PROPOSED CONCEPT PLAN: OPTION 1

SURVEY 2 FEEDBACK: CONCEPT PLAN 1

PROPOSED CONCEPT PLAN: OPTION 1 REVISED

PROPOSED CONCEPT PLAN: OPTION 2 REVISED

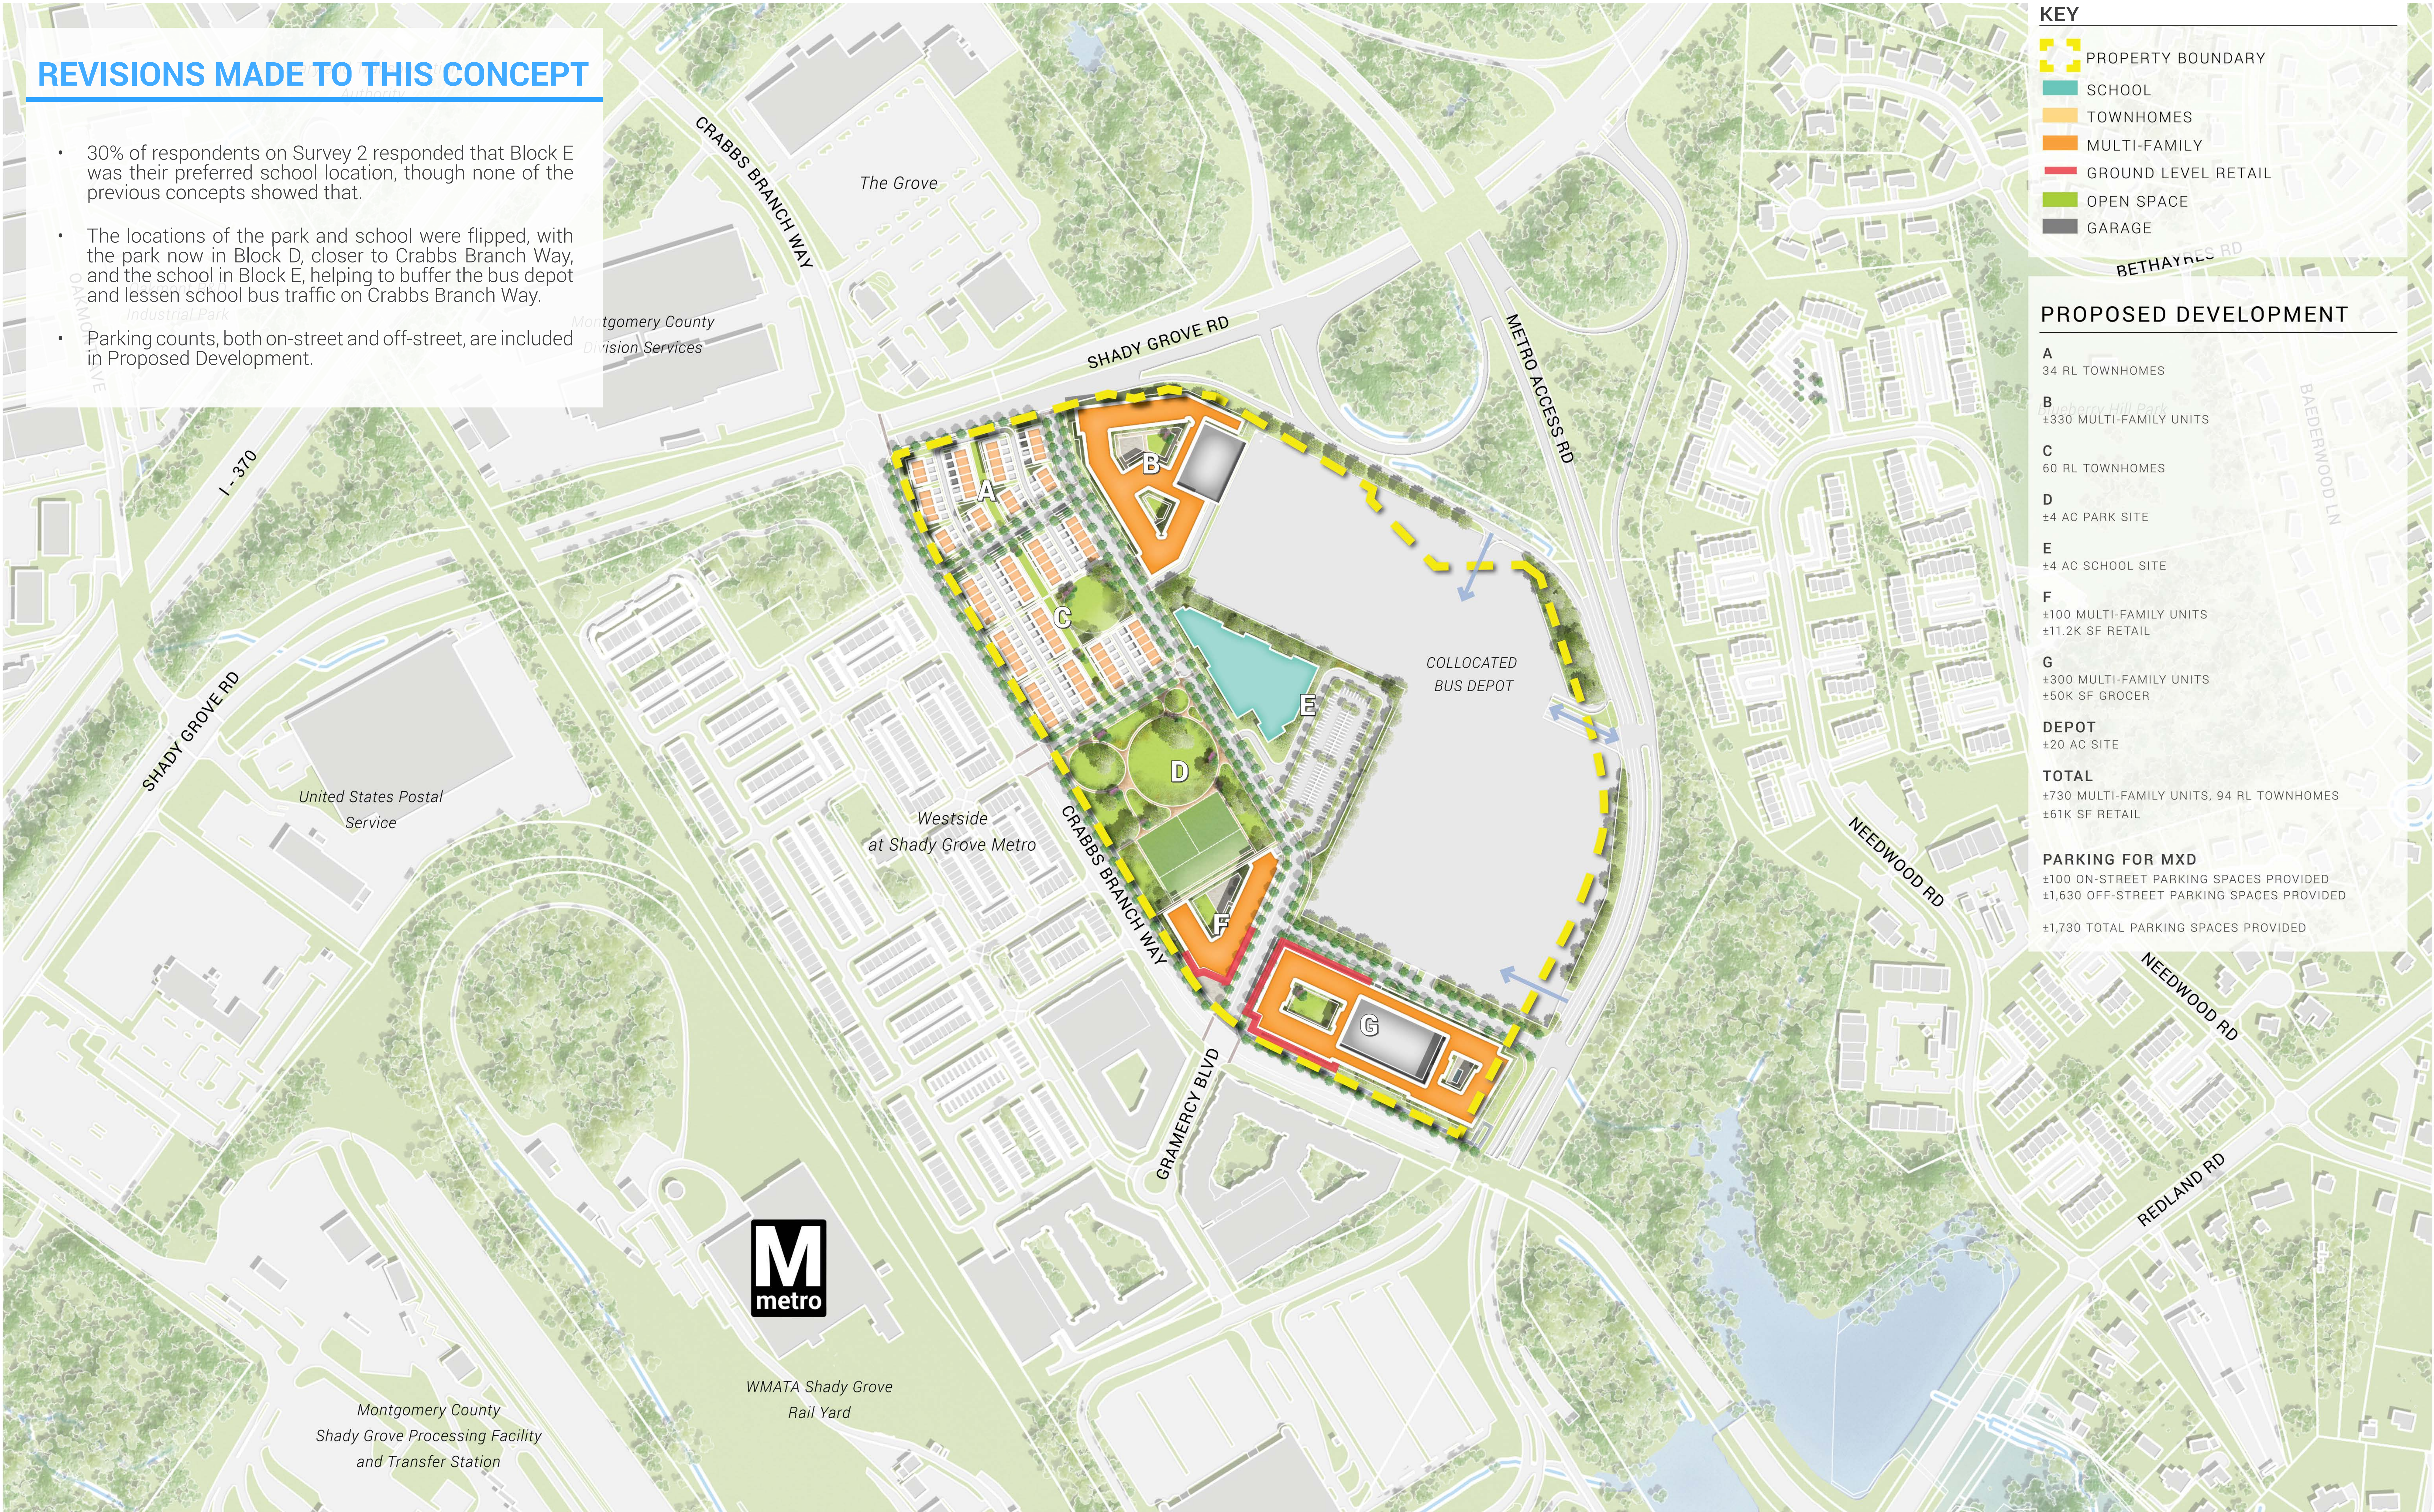
- 30% of respondents on Survey 2 responded that Block E was their preferred school location, though none of the previous concepts showed that.
- The locations of the park and school were flipped, with the park now in Block D, closer to Crabbs Branch Way, and the school in Block E, helping to buffer the bus depot and lessen school bus traffic on Crabbs Branch Way.
- Parking counts, both on-street and off-street, are included in Proposed Development.

PROPOSED CONCEPT PLAN: OPTION 3

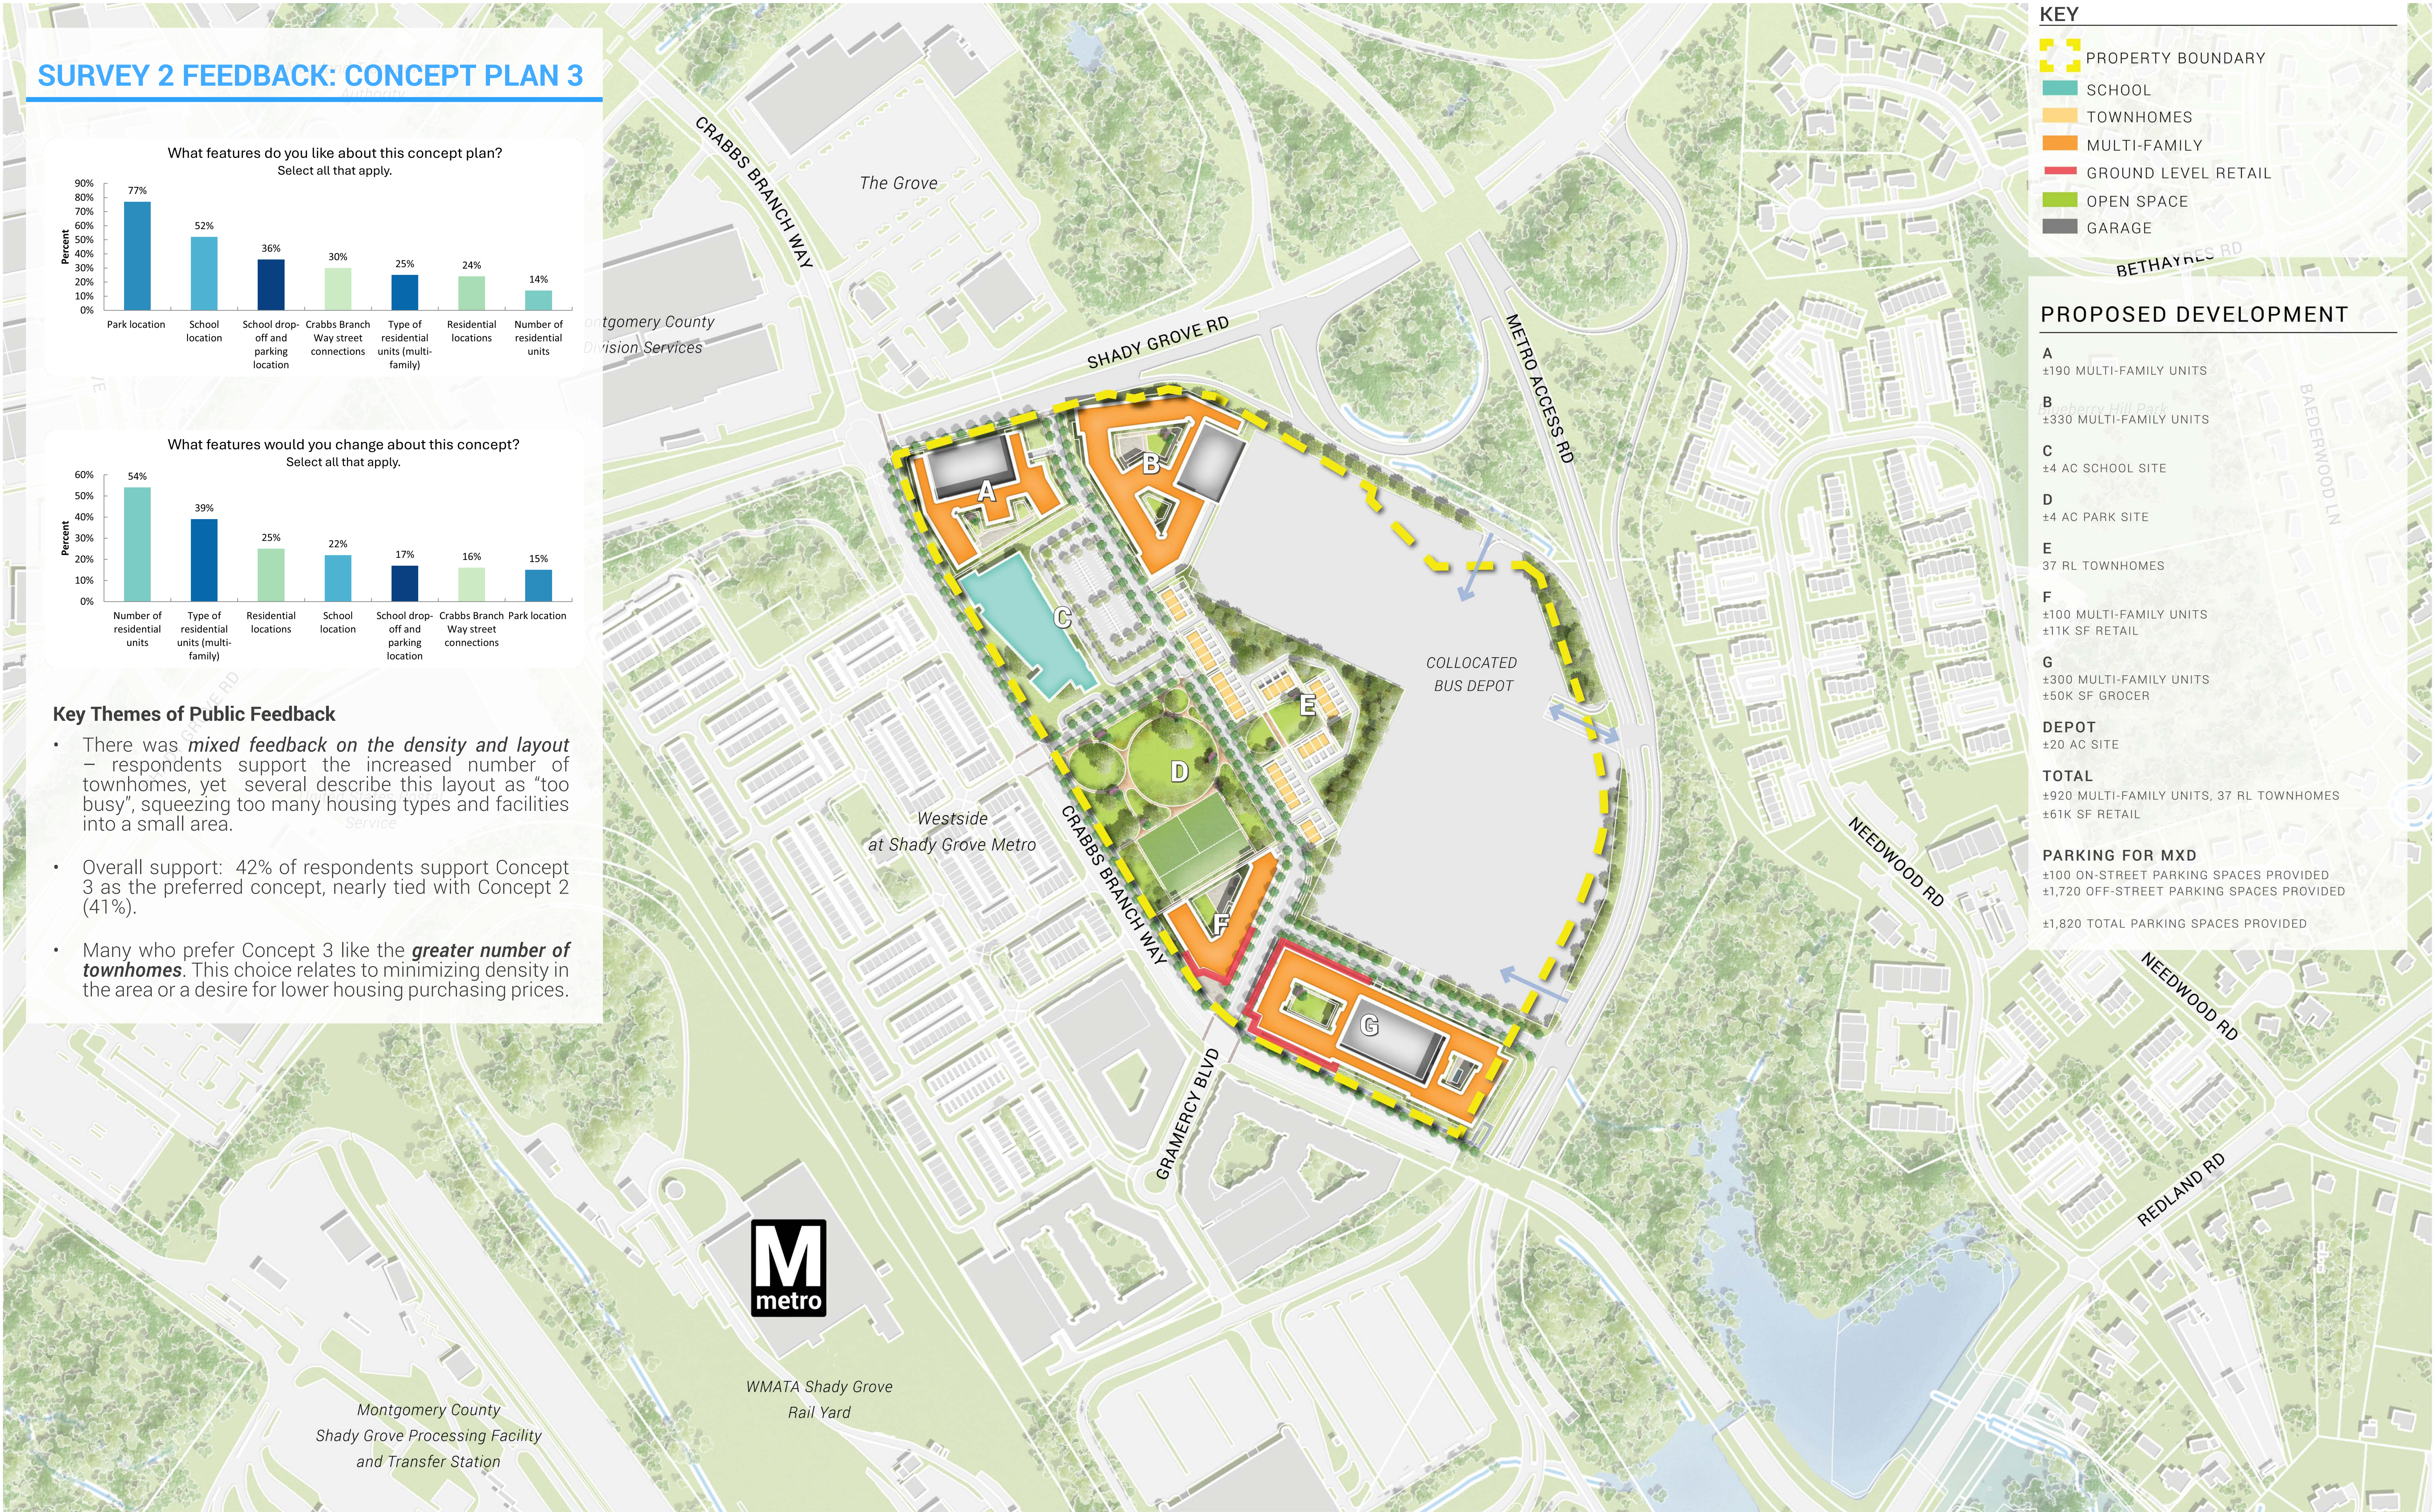
- There was *mixed feedback on the density and layout* – respondents support the increased number of townhomes, yet several describe this layout as “too busy”, squeezing too many housing types and facilities into a small area.
- Overall support: 42% of respondents support Concept 3 as the preferred concept, nearly tied with Concept 2 (41%).
- Many who prefer Concept 3 like the *greater number of townhomes*. This choice relates to minimizing density in the area or a desire for lower housing purchasing prices.

- **None**; this concept plan layout was preferred in the Survey overall, nearly tied with Concept 1.
- Respondents like the **park location in Concept 3** more than any other element in all three concepts, preferring the location of the park on Crabbs Branch Way closest to Gramercy Boulevard.
- 52% like the school location in Concept 3.
- Additionally, a mix of townhomes and multi-family was generally preferred over all multi-family options.
- Parking counts, both on-street and off-street, are included in Proposed Development.
